PDP-8L

TECHNICAL INFORMATION

Engineering Change Order Log

ECO SYNOPSIS FOR LOGIC OR OPTION

ECO #8L-00013 D-BS-8L-0-2 - NEW REV. C

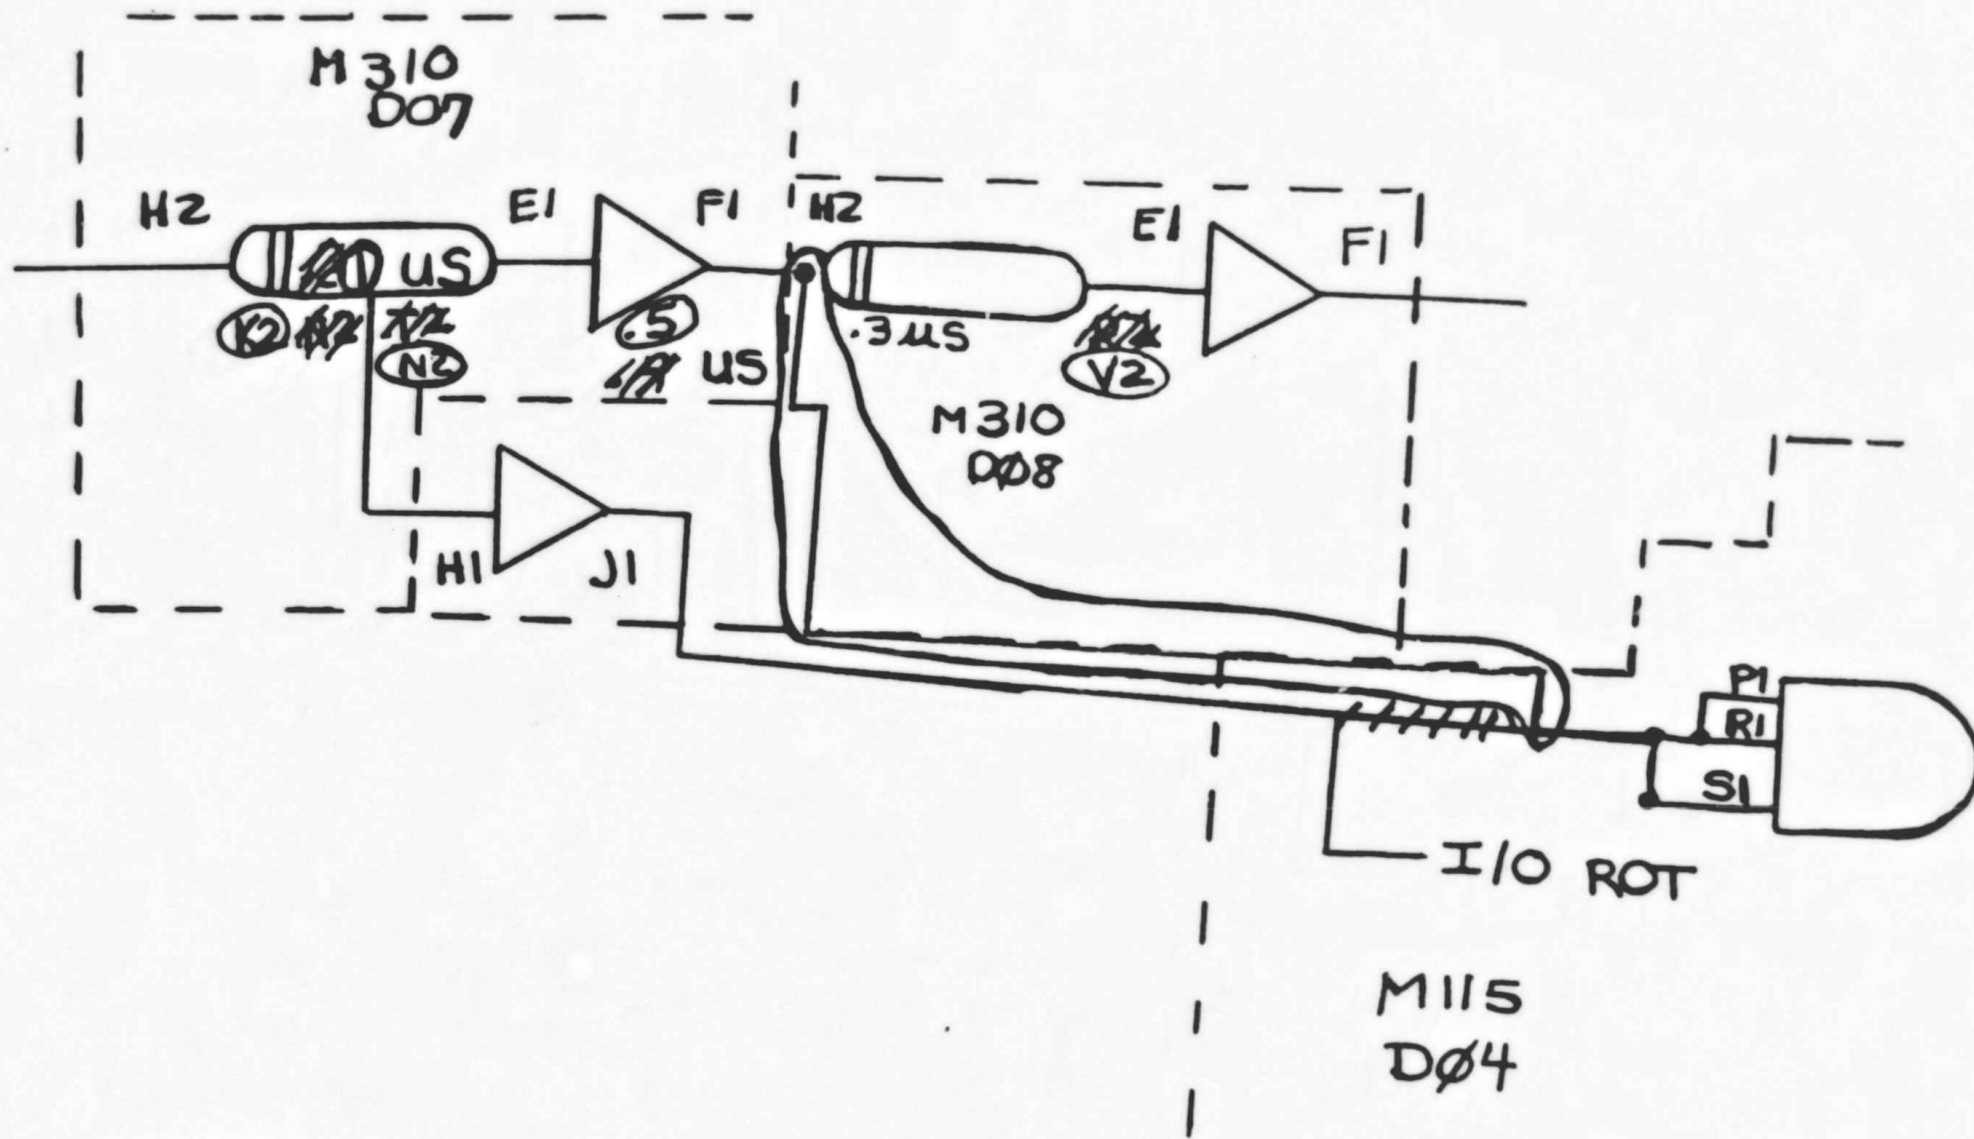
1. COULD NOT SET EA LIGHT WITH L.A. SWITCH WHEN EX. MEM. OPTION ADDED.
2. L.A. SWITCH WAS LOADING S.R. INTO M.B. & M.A.
3. COULD NOT PROTECT MEM. EX. LAST PAGE OF MEMORY WITH PROTECT SWITCH.
4. MEMORY WAS NOT PROTECTED DURING 3 CYCLE BREAK.
5. WIRE LIST ERRORS

1. CHANGED TIMING ON KEY CL. & KEY LOAD
2. ADDED GATE AT C15
3. CHANGED EMA TO BEMA. ADDED LOGIC TO MC8L LOGIC
4. ADDED WORD COUNT TO PROTECT GATE.
5. CORRECT WIRE LIST.

ECO #8L-00031 D-35-8L-0-13 NEW
REV. D

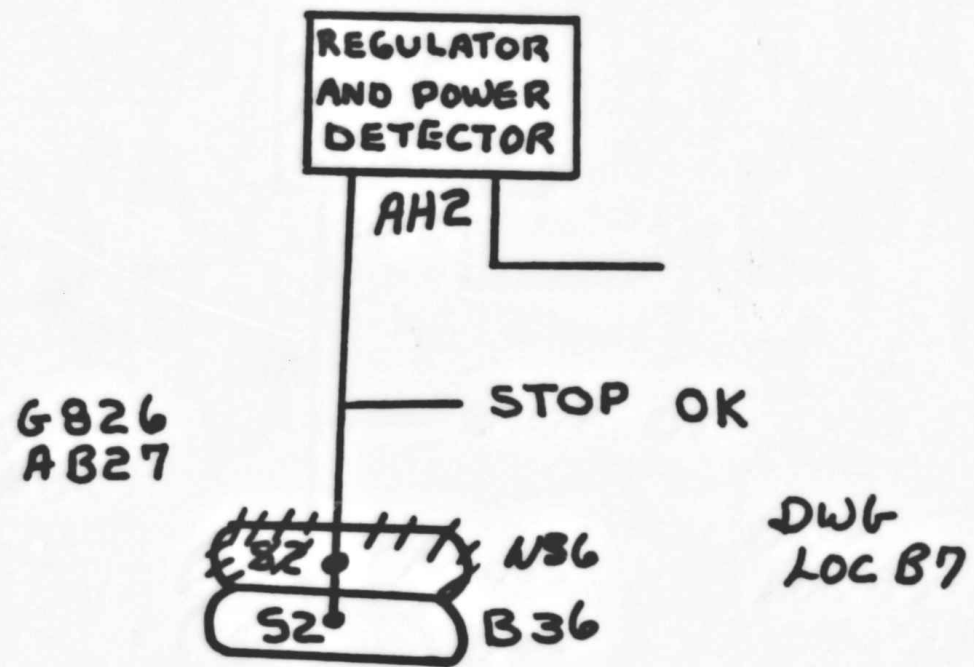
REMOVE A36S2 FROM RUN

ECO-8L-00045 D-BS-8L-0-2 NEW REV E

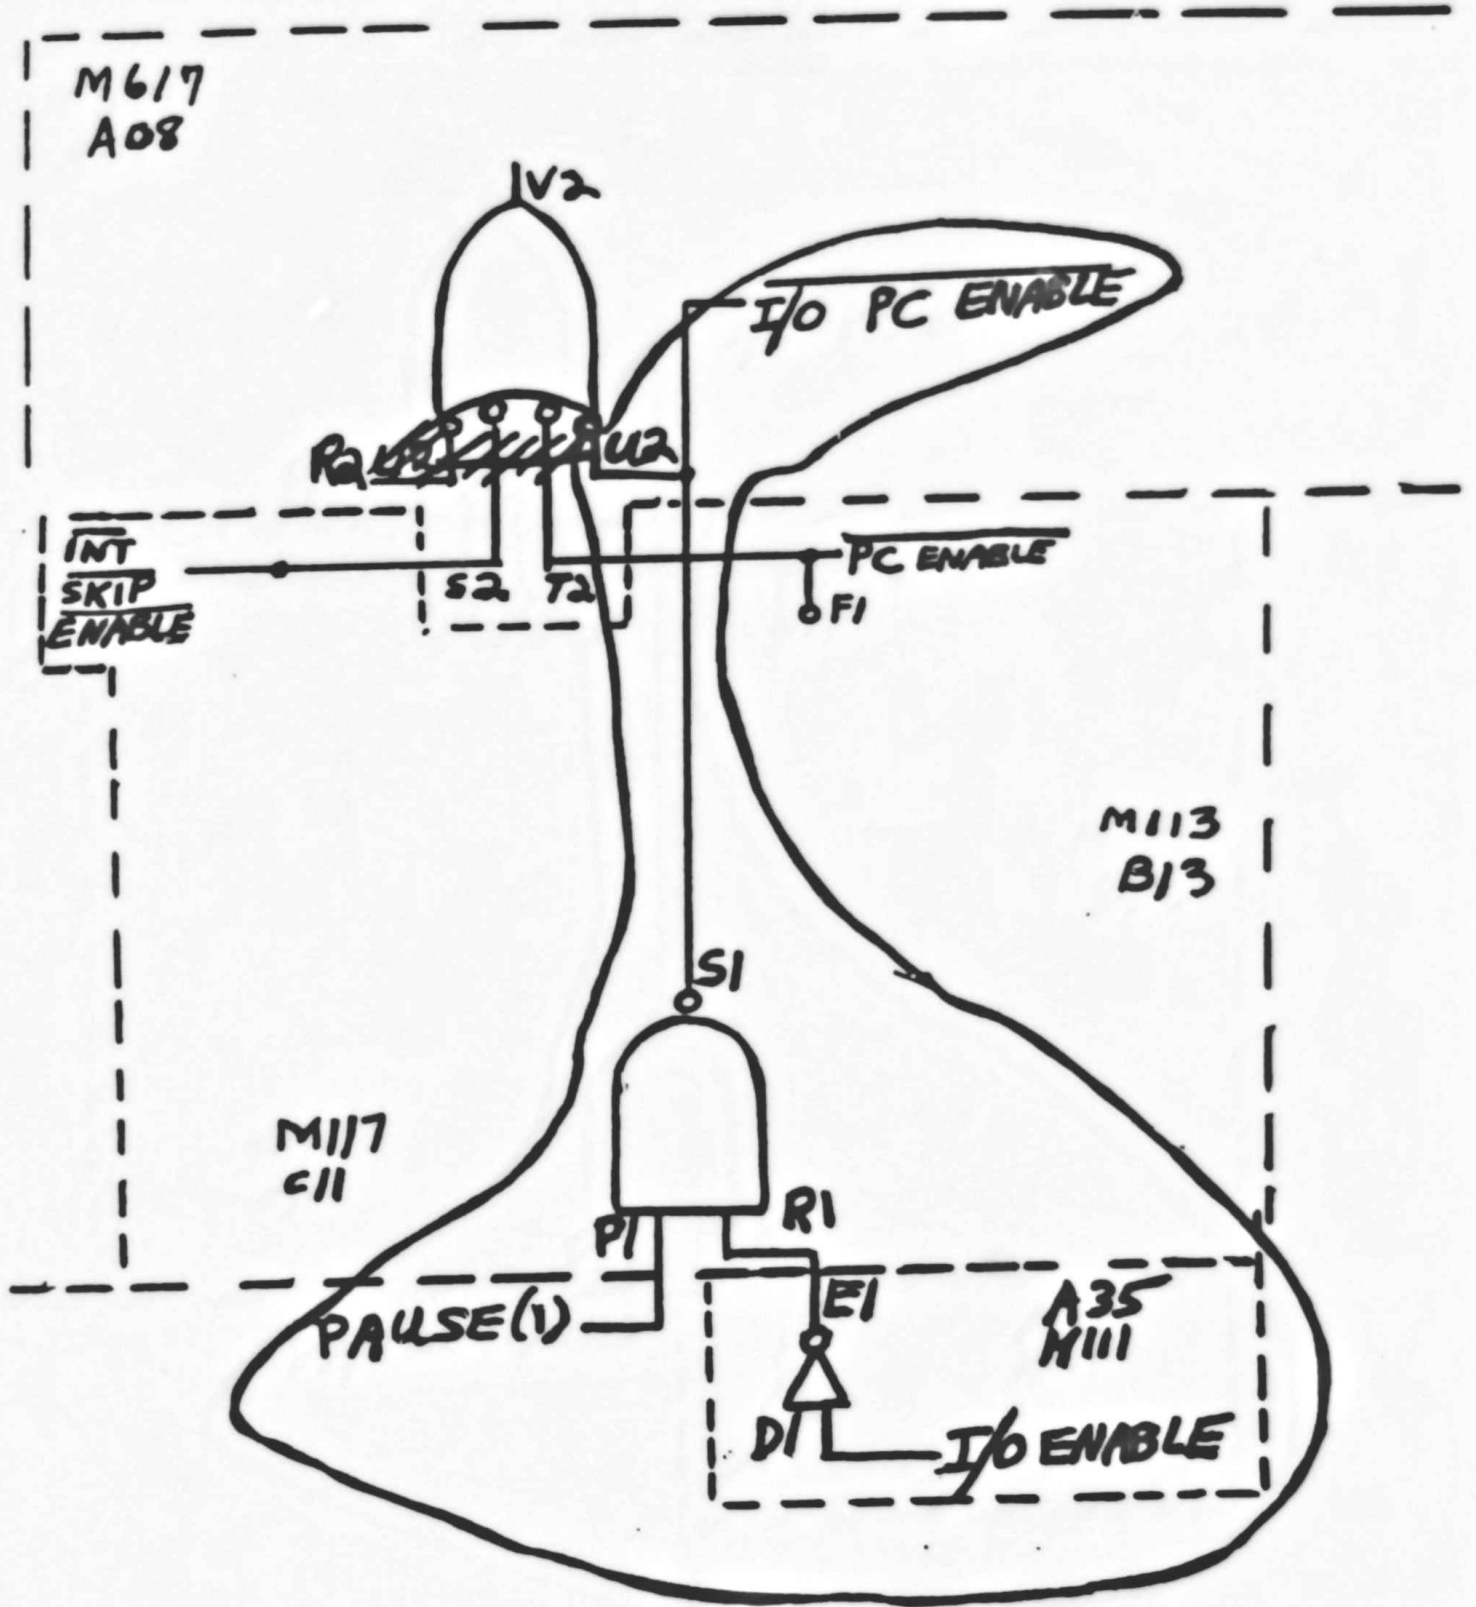
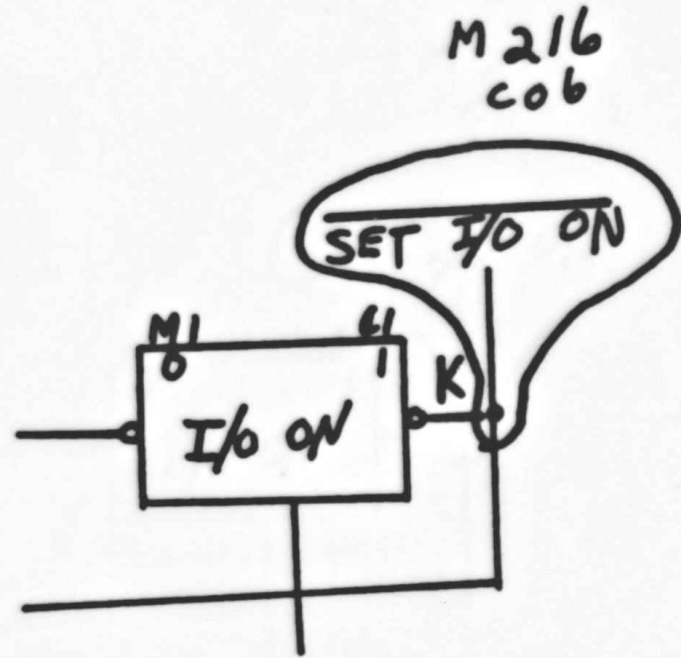
CHANGE AS PER LOGIC PRINTS TO ALLOW FAST FLAG TESTING IN PERIPHERALS.

ECO 8L-00059 D-BS-8L-0-2 NEW REV. F

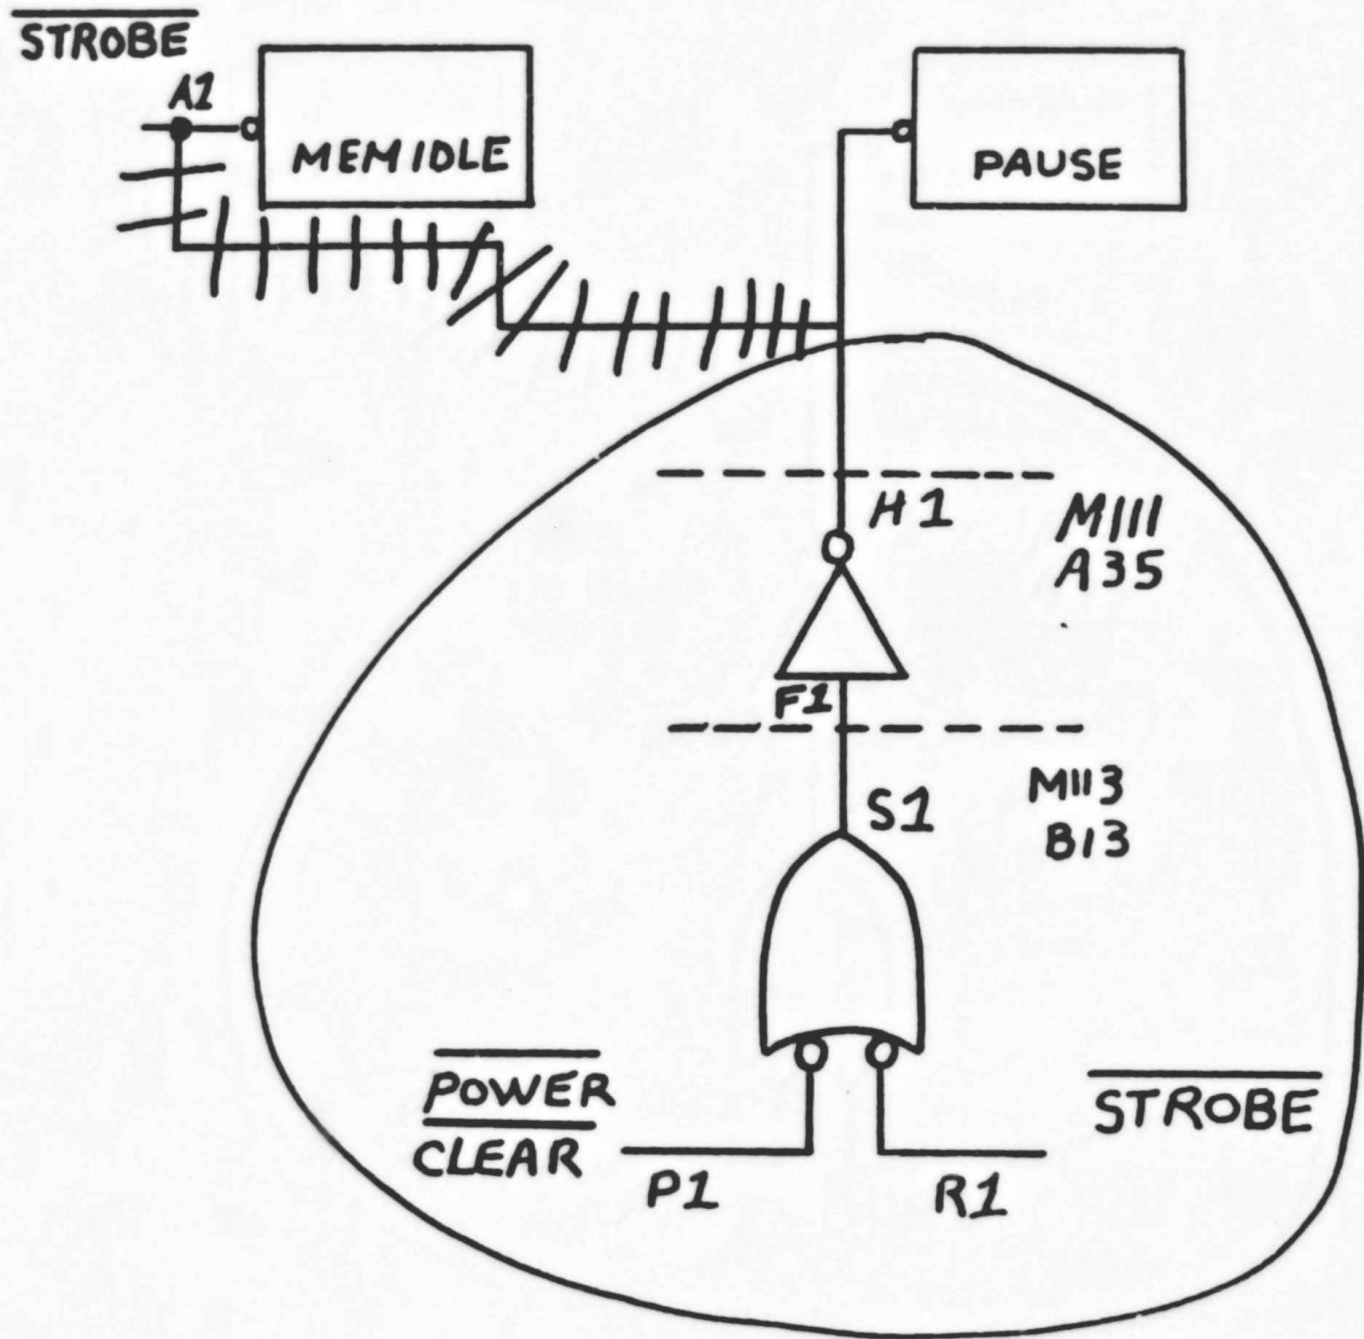
PROBLEM:
 THE PAUSE F.F. CAN COME ON IN EITHER STATE WHEN THE COMPUTER IS FIRST TURNED ON. IF IT COMES UP IN THE "1" STATE, LOAD ADD HAS TO BE HIT TWICE BECAUSE THE PAUSE INHIBITS PC ENABLE.

CORRECTION:
 ADD POWER CLEAR TO PAUSE F.F.

ECO 8L-00068 D-B5-BL-0-10 NEW REV C

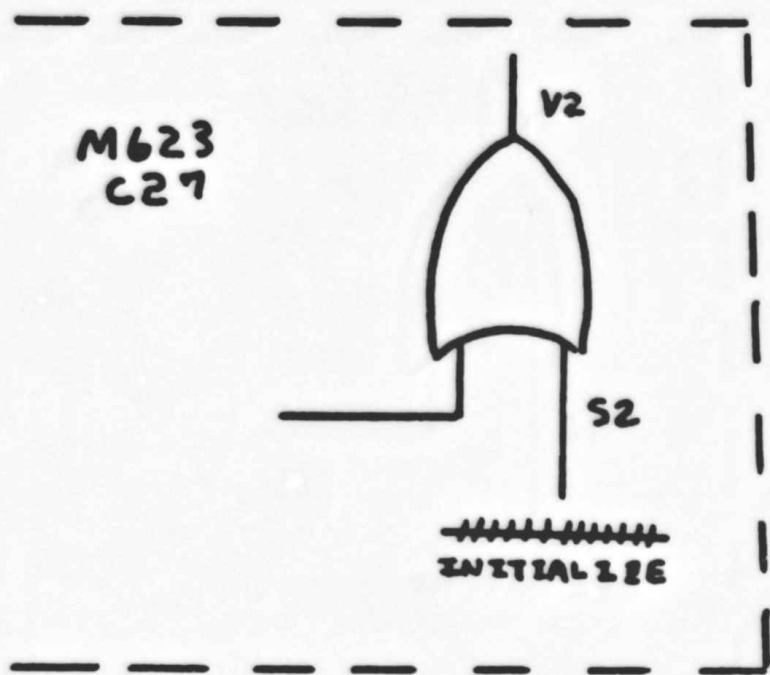
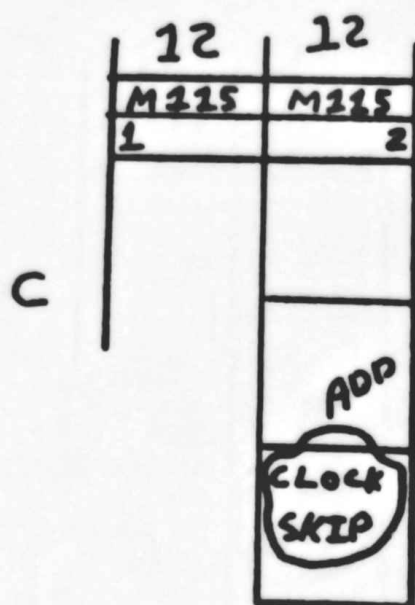
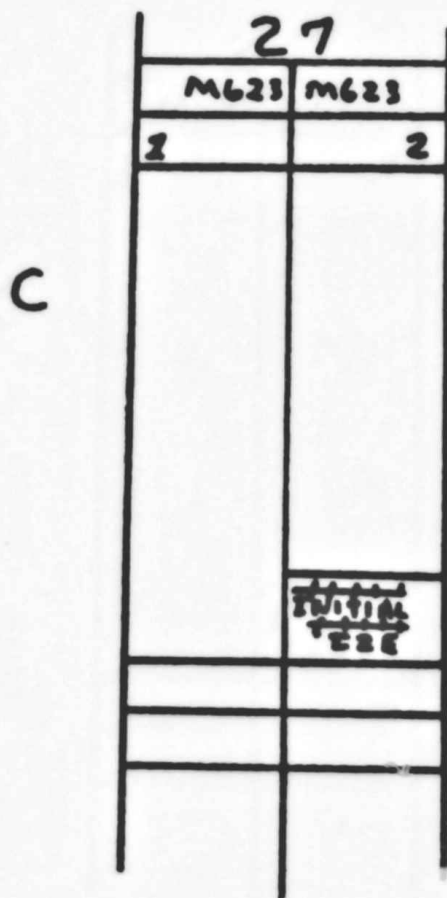
- CHANGE POLARITY OF BUS ON 8L TO KEEP BUS THE SAME.
- CORRECT MUL.

ECO 8L-00071 D-AD-7005906-0-0 NEW REV. B

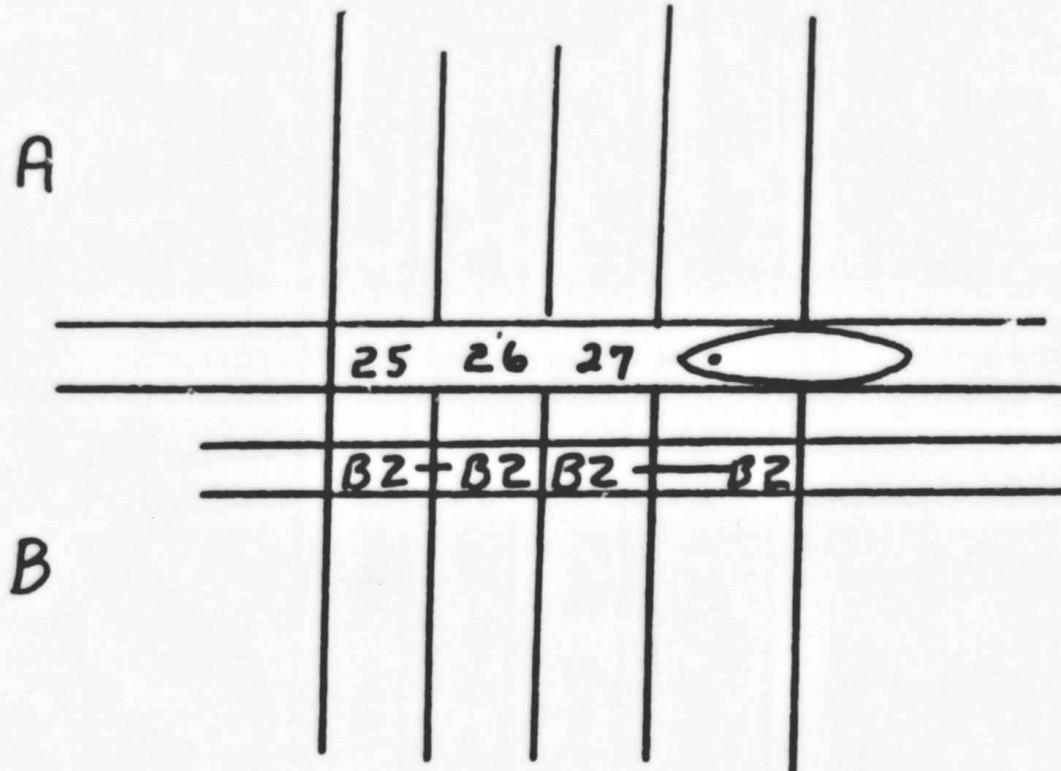
REMOVE THE BUSSING FROM B27B2 TO B28B2

ECO 8L-00078 J-BS-8L-0-2 NEW REV K

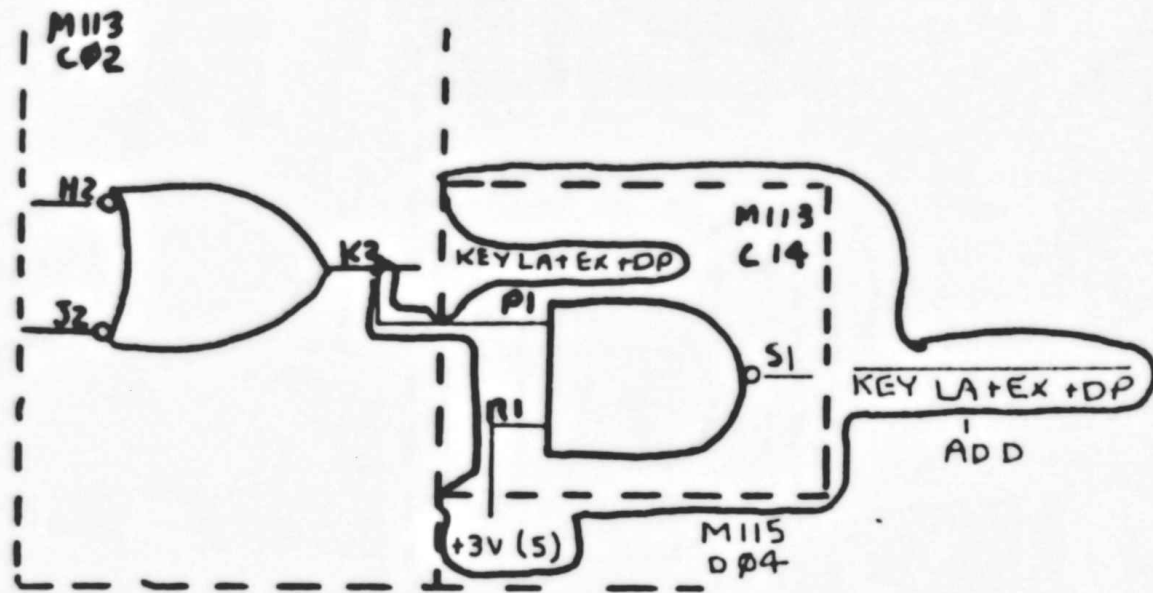
1. ADD KEY LA+EX+DP TO CLEAR INT SYNC, WHEN DOING A KEY FUNCTION.

ECO 8L-00083 D-BS-8L-0-2 NEW REV L

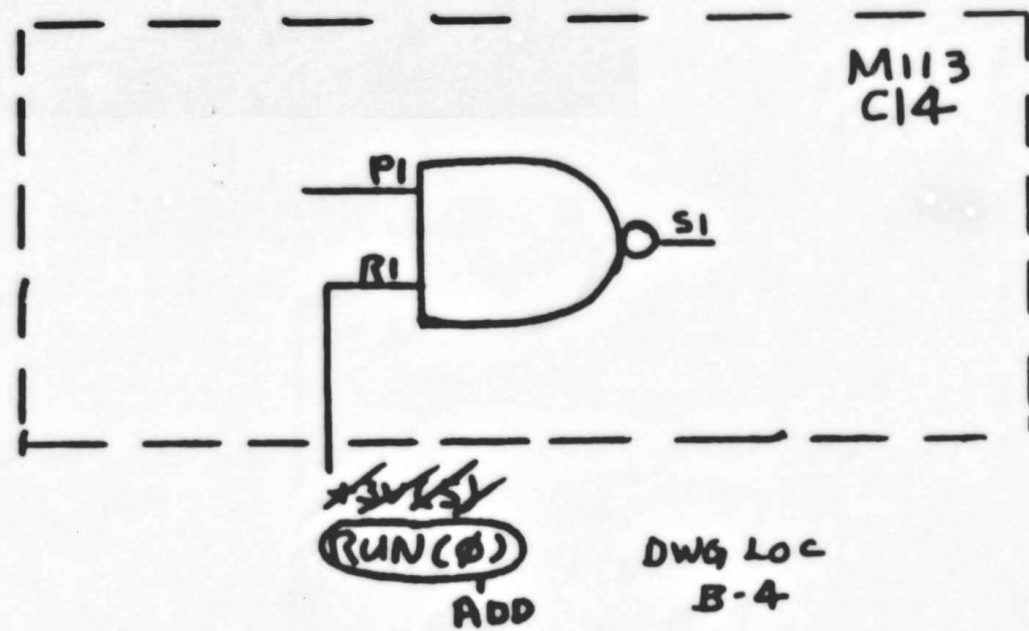
BL 00083	BL 1800-2054> ALL BL WITH ECO BL-00078	F	NOV 69 - CORRECTS AN ERROR IN ECO BL-00078; GATES "RUN (0)" WITH KEY FUNCTIONS SO THAT "KEY LA+EX+DP" IS DISABLED WHEN THE BL IS RUNNING.
BL 00084	N.A.	P	NOV 69 - CORRECTS THE WIRE LIST TO SHOW CURRENT LOOPS AND TWISTED PAIRS AS HAND WRAPS.
BL 00085	BL 100-2346>	F	DEC 69 - CORRECTS LOGIC AND SPECIFIES REVISIONS OF 0826 AND 0785 MODULES WHICH MUST BE USED TO PERMIT THE KP8L POWER FAIL OPTION TO OPERATE PROPERLY WITH MCBL. 0785 REVISION E OR LATER AND 0826 REVISION H ARE REQUIRED IN THE BL. 0785 REVISION E OR LATER IS REQUIRED IN THE BABB IF IT IS PRESENT.
